TRAILS AT OVERLAND RANCH- FILING 01

SITE PLAN

SHEET TITLE:
TRACKING SHEET

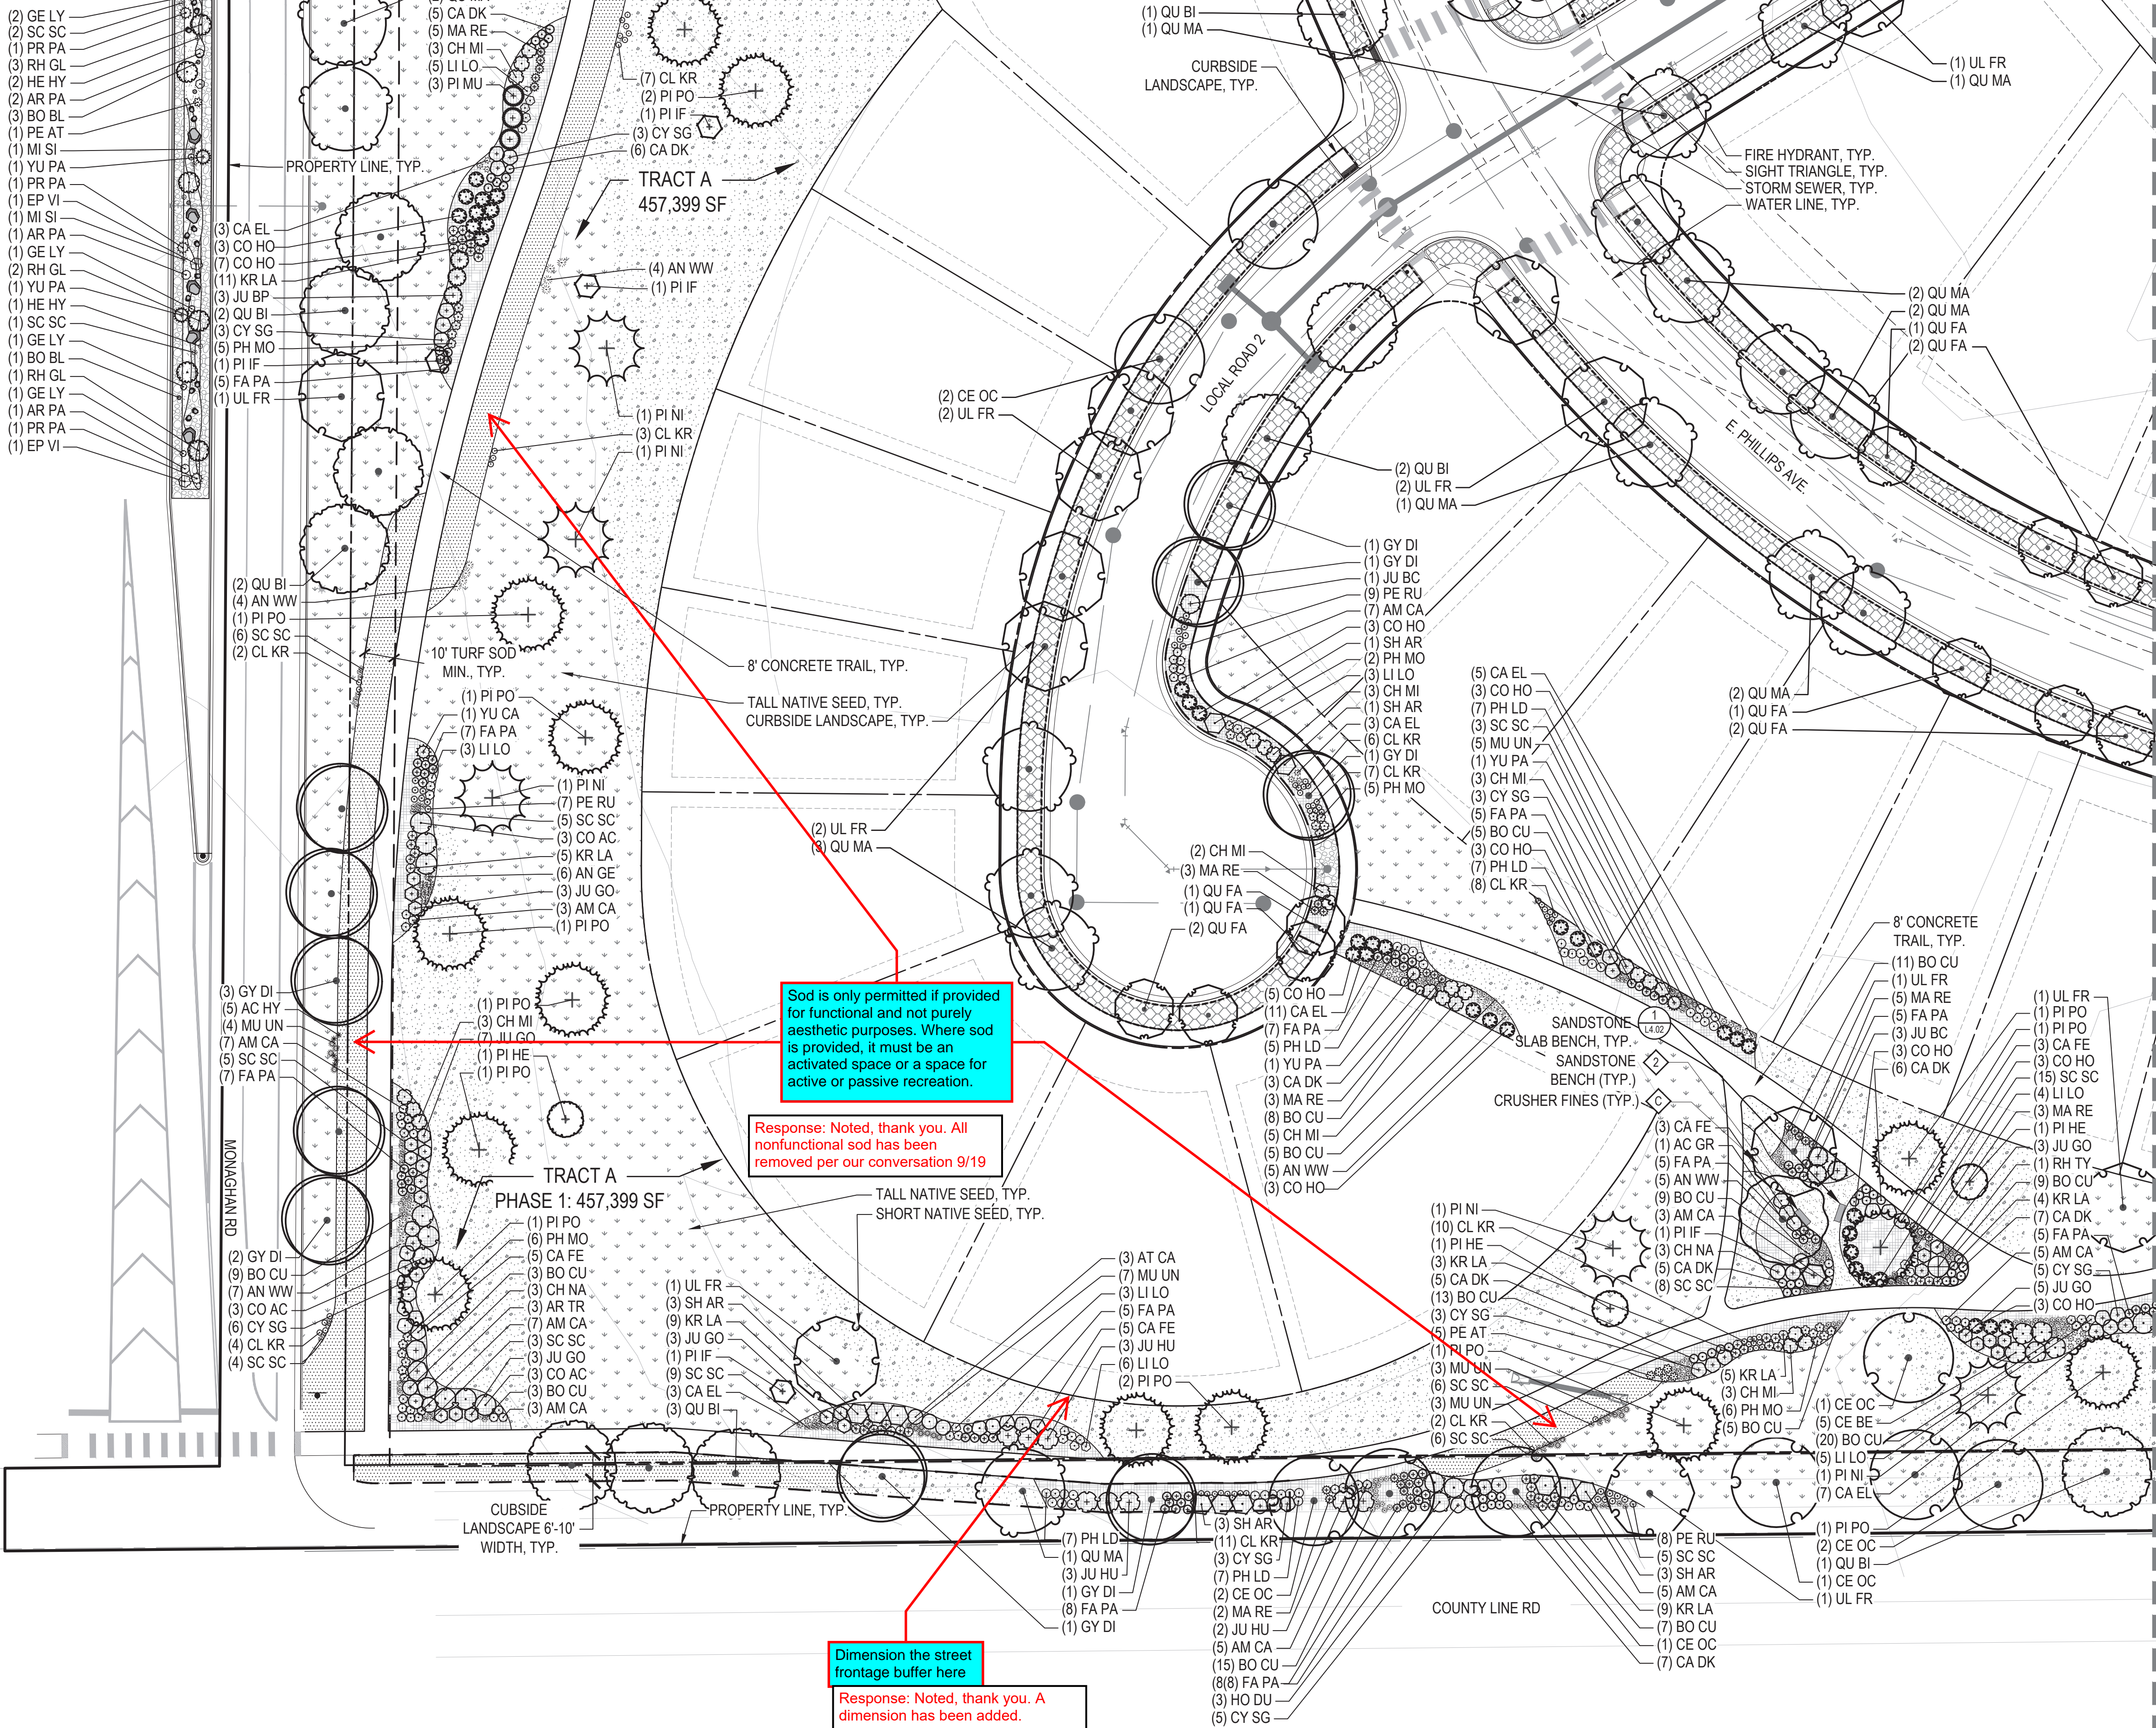
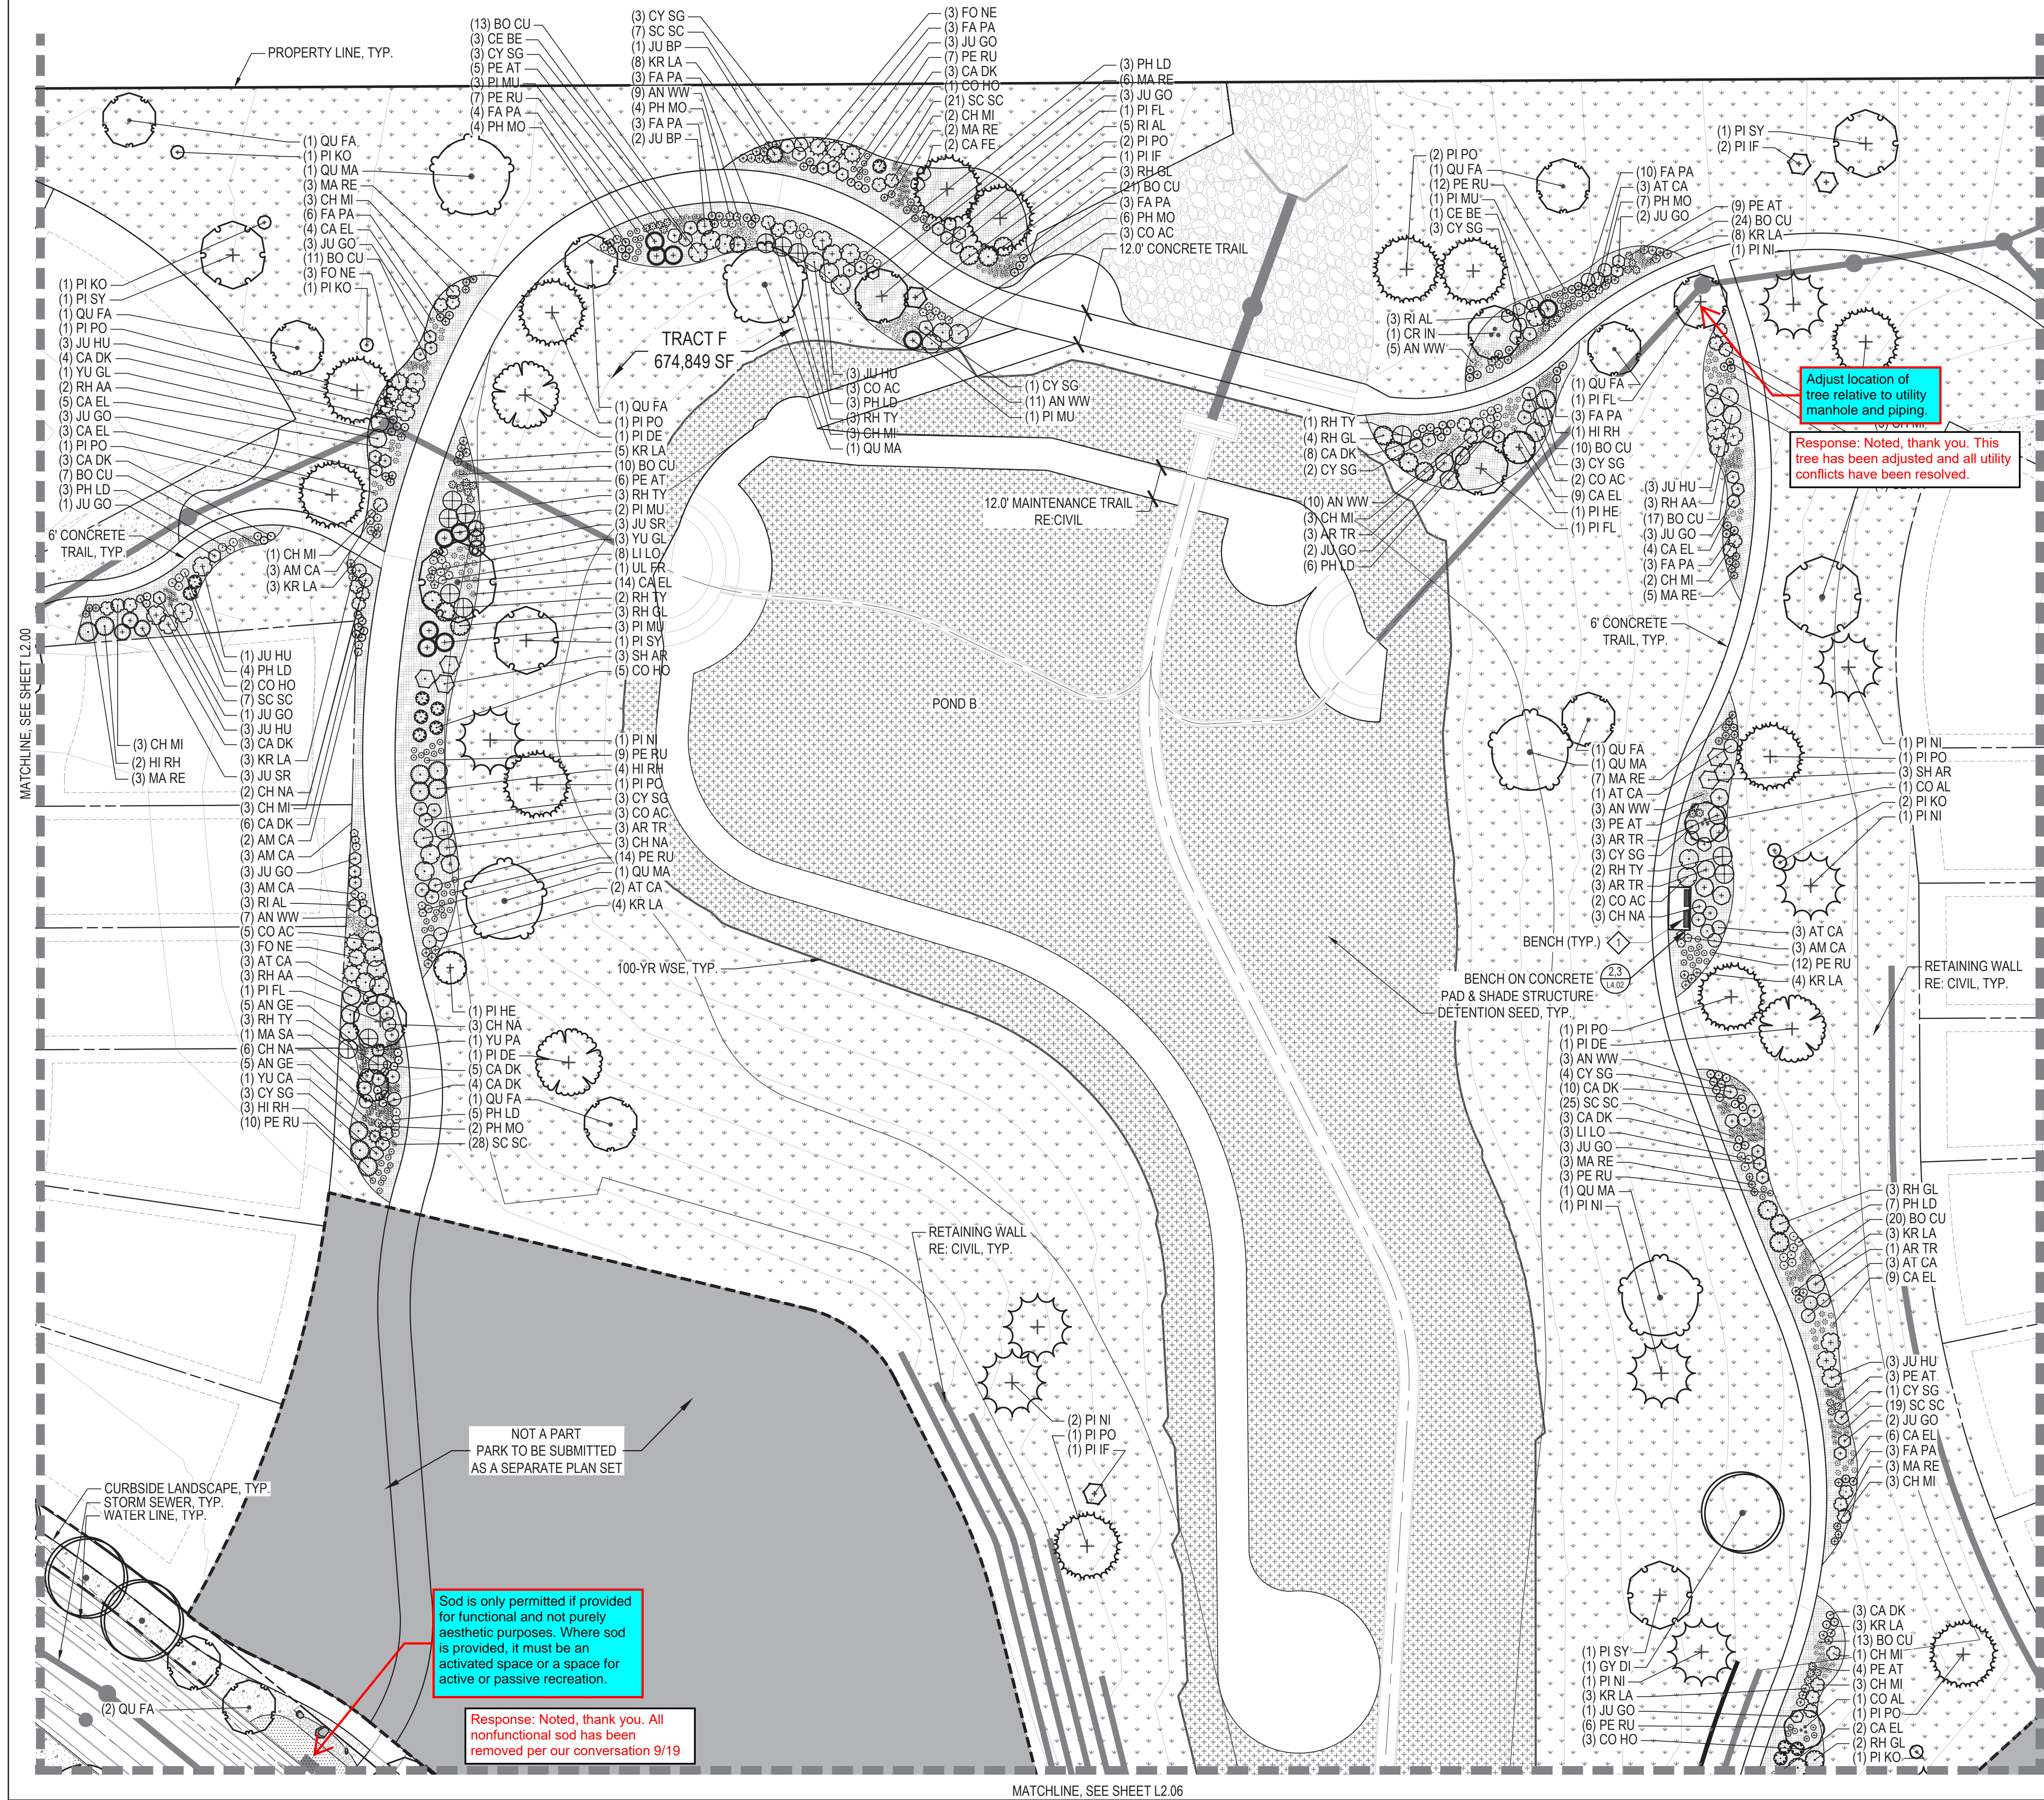
Sod is only permitted if provided for functional and not purely aesthetic purposes. Where sod is provided, it must be an activated space or a space for active or passive recreation.

Dimension the street frontage buffer here

Response: Noted, thank you. All nonfunctional sod has been removed per our conversation 9/19

Response: Noted, thank you. A dimension has been added.
